**RE: Administrative Design Review Case No. PADR-003056-2024
506 West Elk Avenue**

DESIGN REVIEW STAFF REPORT – COMMERCIAL / INDUSTRIAL / MIXED USE

The applicant proposes to construct a detached one-story, 1,000-SF metal building as accessory storage within a landscaped parking lot for an existing manufacturing company on a 18,750-SF parcel of 3 lots, located in a mixed-use corridor in the IMU-R (Industrial/Commercial-Residential Mixed Use) Zone.

Parking plan
Landscape Plan

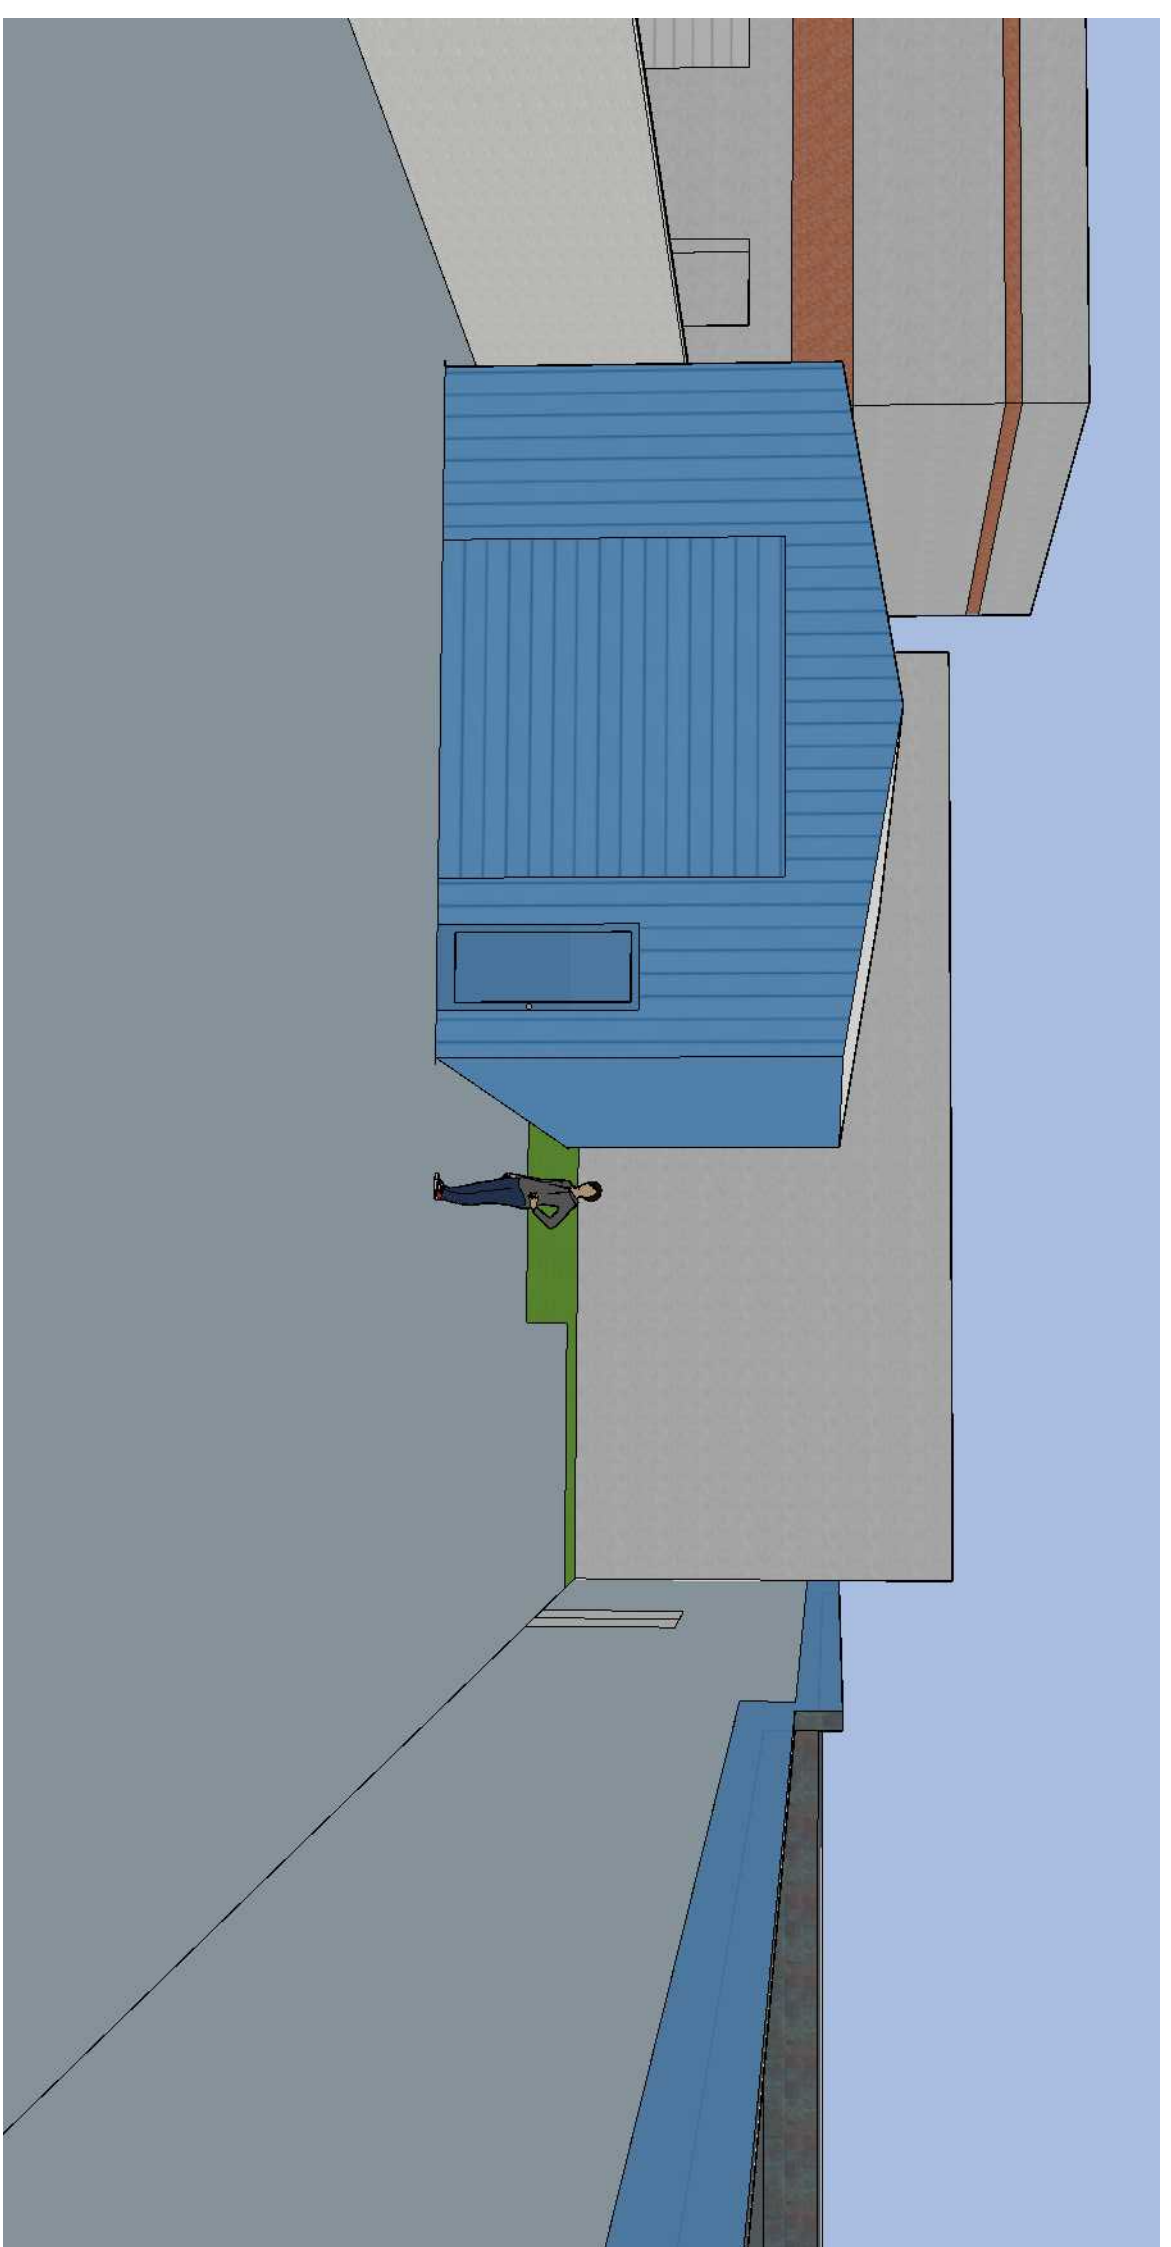
While landscaping is generally depicted on the site plan, landscape plans were not provided for the site, as required by GMC §30.31.020, which must include interior parking lot landscaping, including concrete curb, irrigation system, and materials, as required by GMC §30.32.160. A condition is included, prior to the issuance of any building permit, that all landscape and irrigation plans shall be submitted to staff for review and approval prior to plan check submittal.

The project does not include an elevation and detail of the enclosure for trash and recycling. A condition is included, prior to the issuance of any building permit, that an elevation and detail of the enclosure for trash and recycling, as required by GMC §30.30.030, shall be submitted to staff for review and approval prior to plan check submittal.

Lighting location and detail are not depicted on the plans, as required by GMC §30.30.040. A condition is included, prior to the issuance of any building permit, that a site plan, elevation and cut sheet corresponding to any site lighting and fixtures shall be submitted to staff for review and approval prior to plan check submittal.

While drive isles, parking lot striping, and landscape areas are generally depicted on the site plan, the final site and landscape plans must detail the configuration and features of paving materials at the driveway entrance, including use of permeable paving when possible, and identifying material and color as it relates to the overall design. A condition is included, prior to the issuance of any building permit, that revised plans for site and landscaping shall include decorative paving materials at the driveway entrance, and said plans shall be submitted to staff for review and approval.

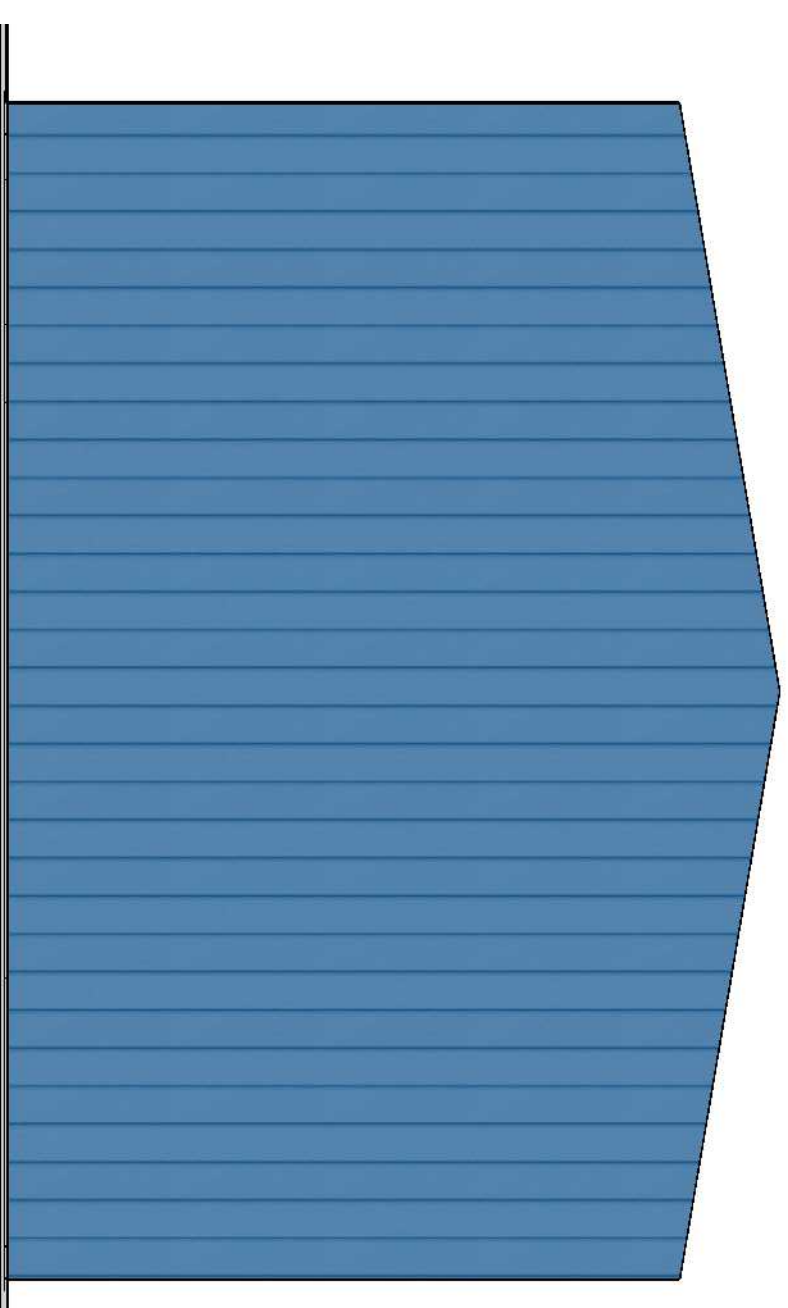
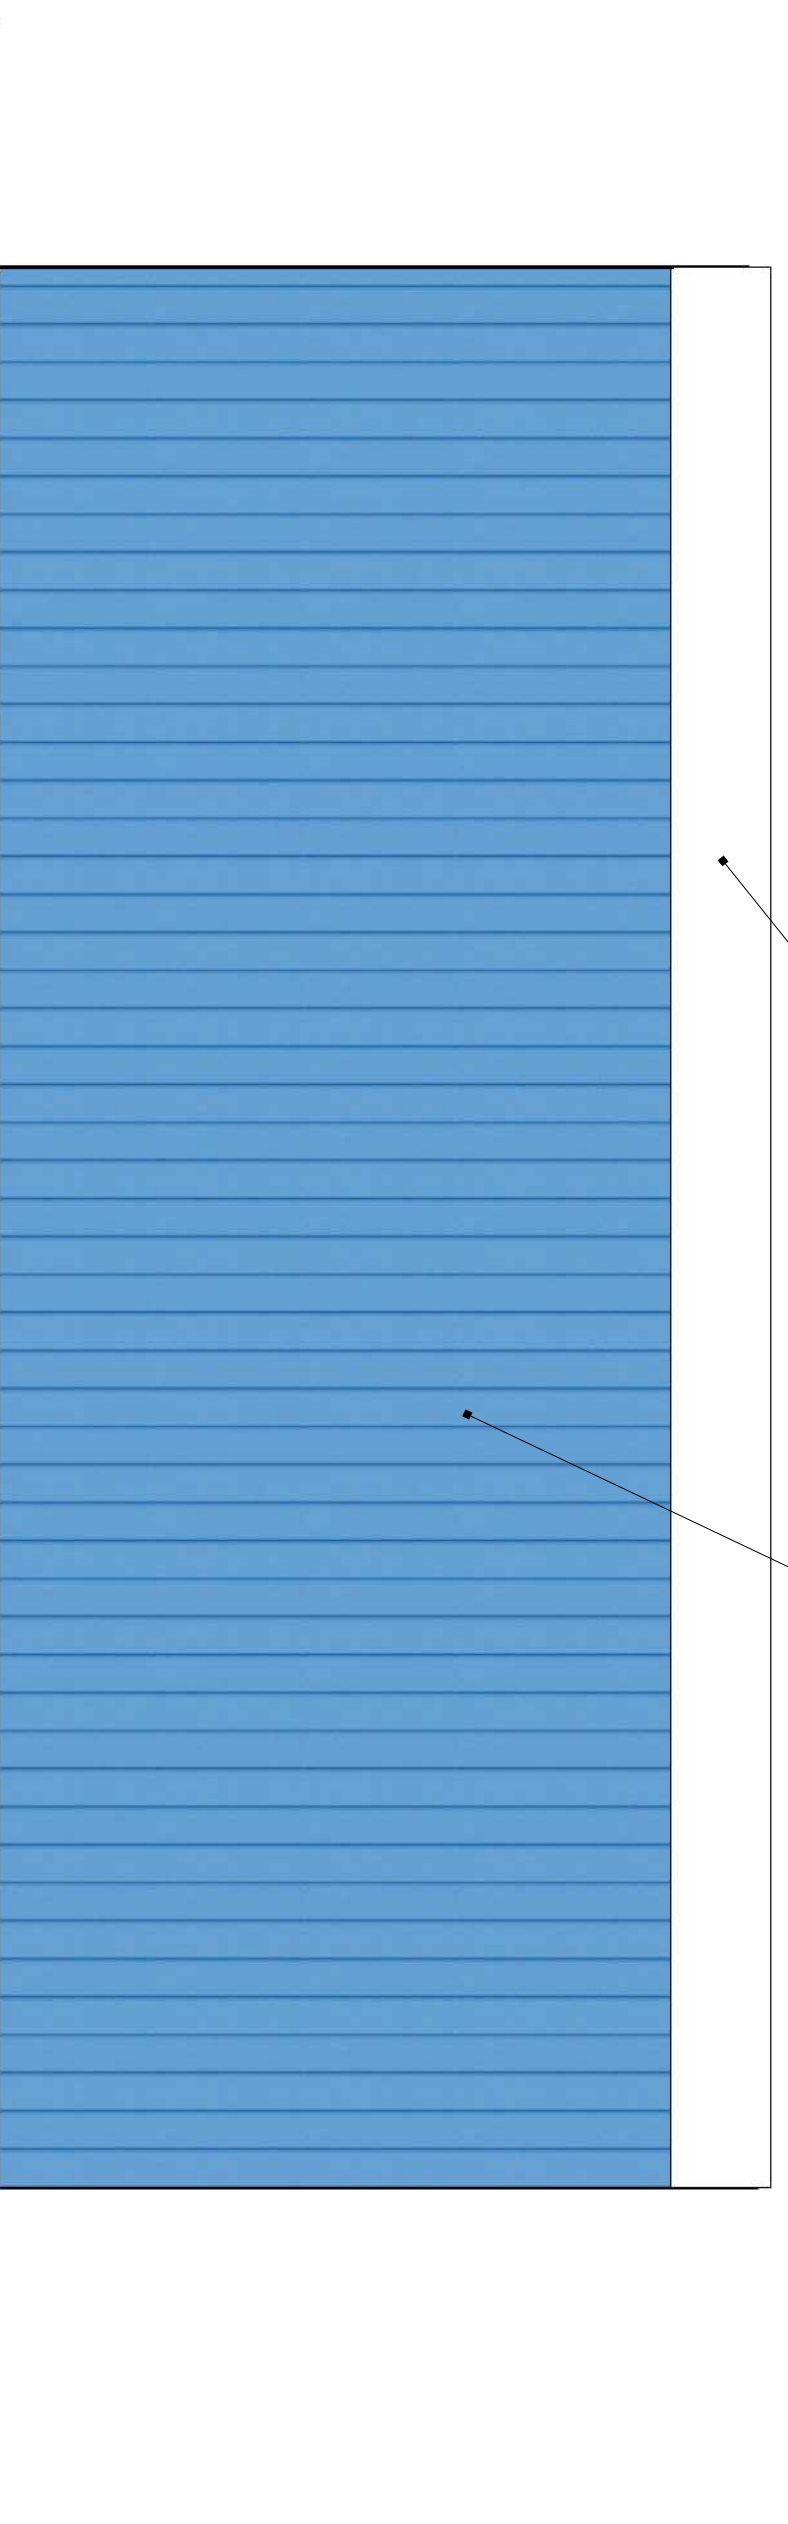
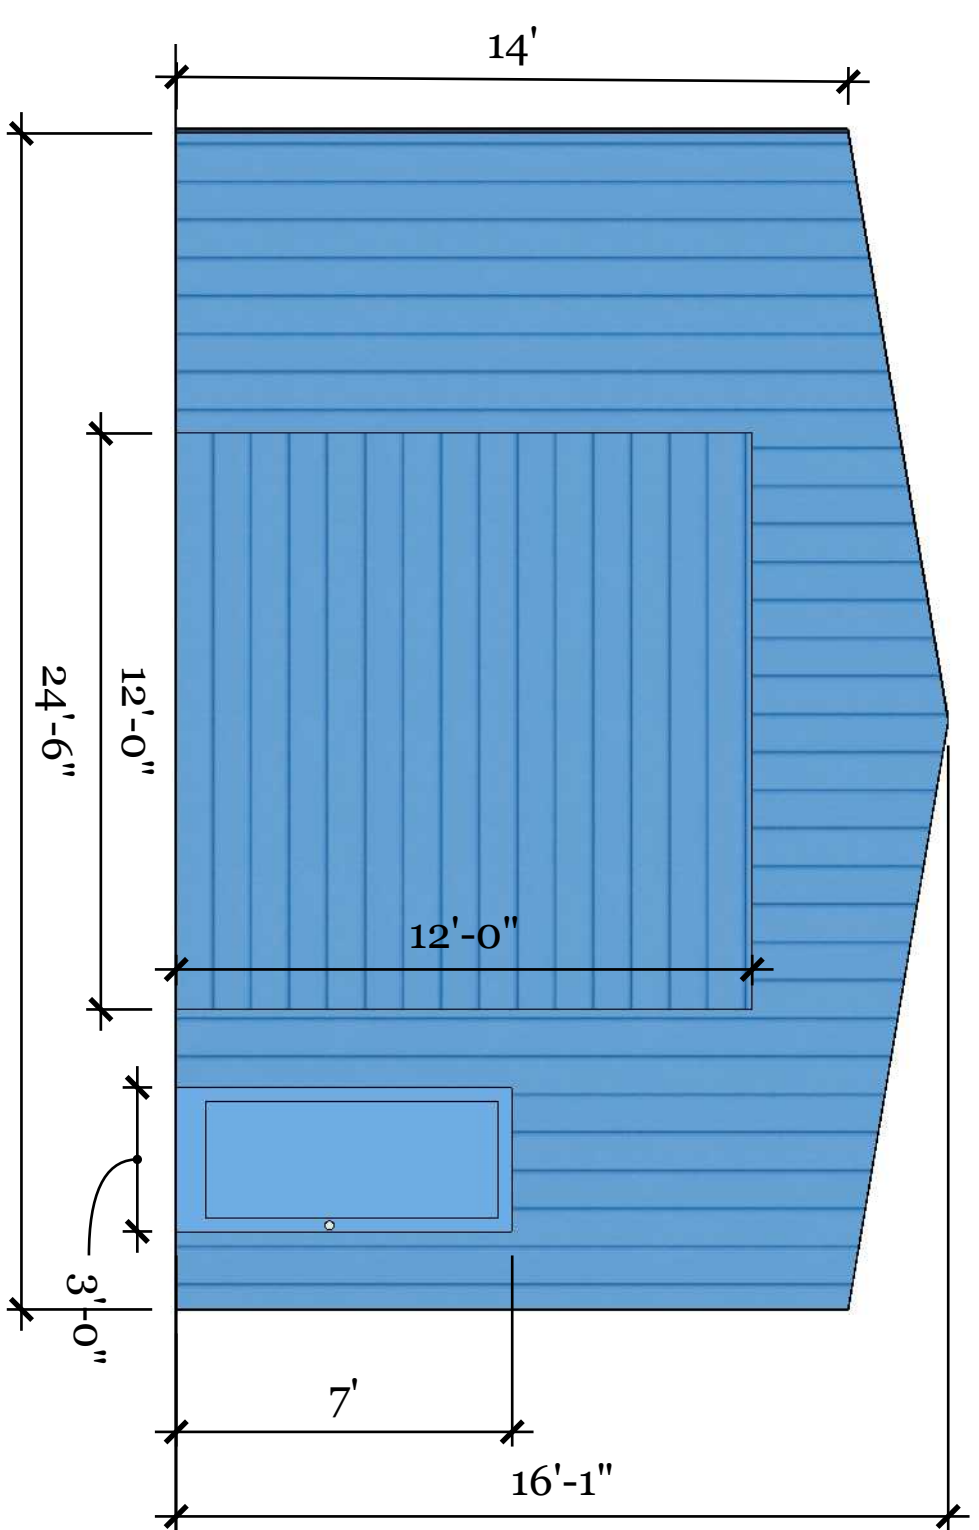
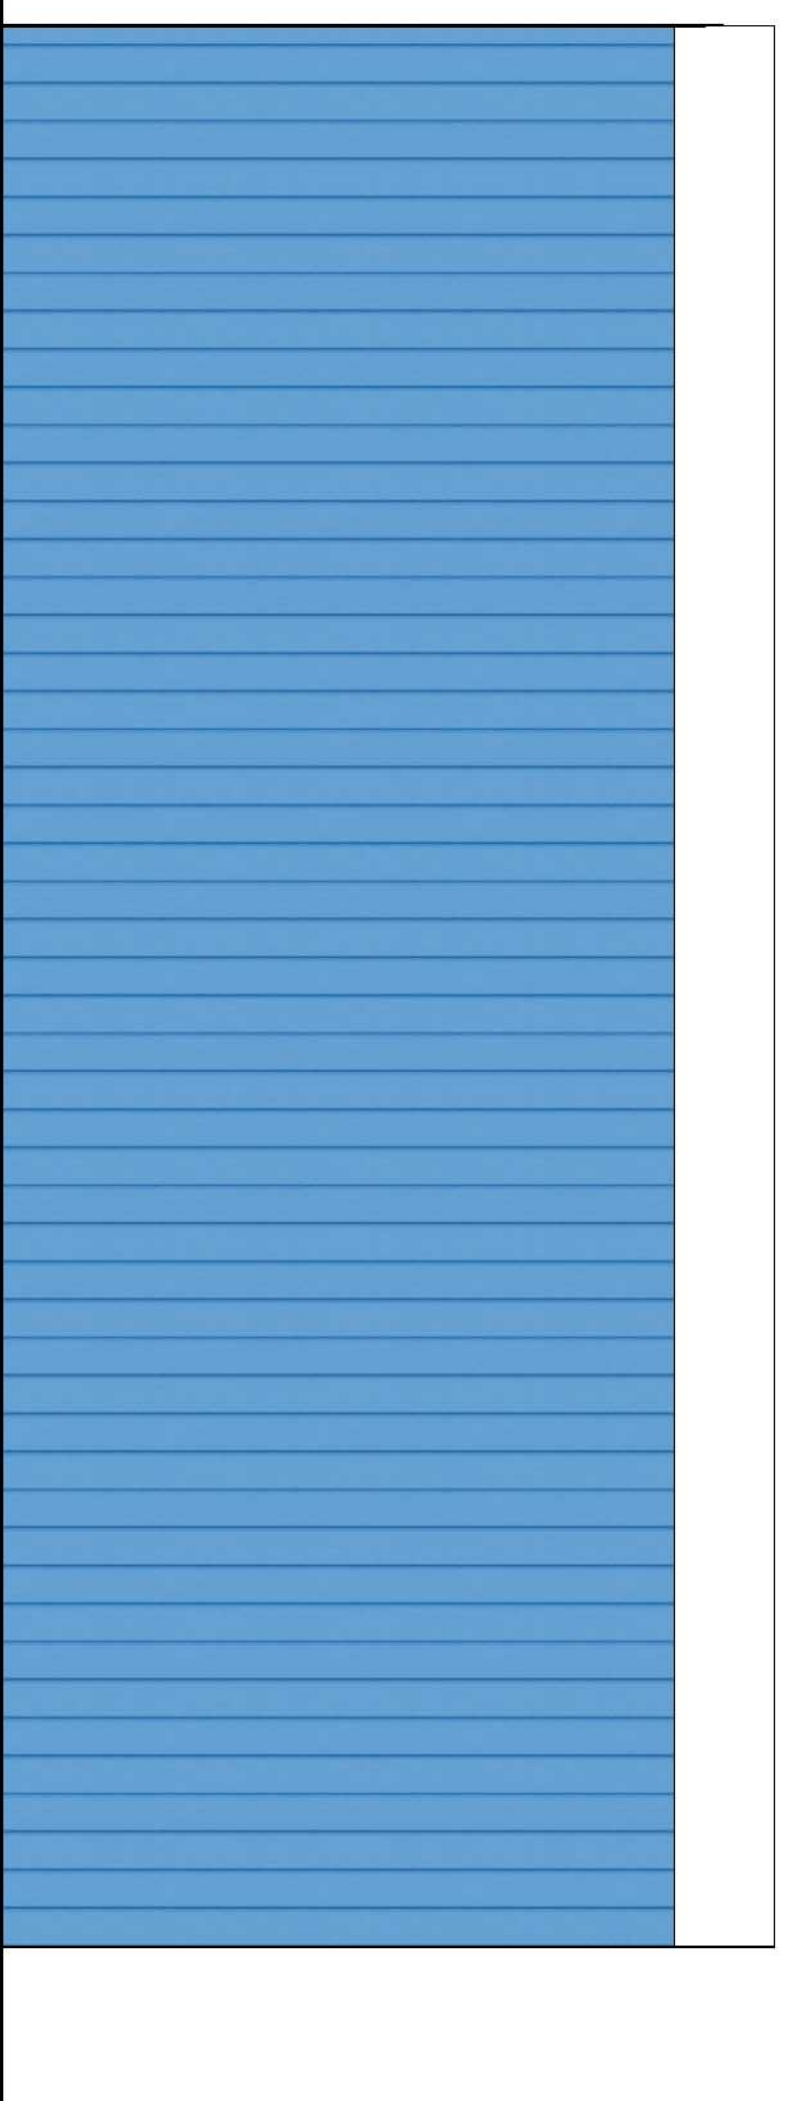
- The proposed industrial storage building relates to its surrounding context of mixed uses.
- While the building is generally not articulated, it is well-positioned at the rear property boundary away from the street.
- While the height of the proposed building is slightly taller than the adjacent building, it does not exceed the maximum height of the existing building on the far west side.
- The proposed plan includes landscaped open space and interior parking lot landscaping that provides a visual buffer between the new storage building and the street.
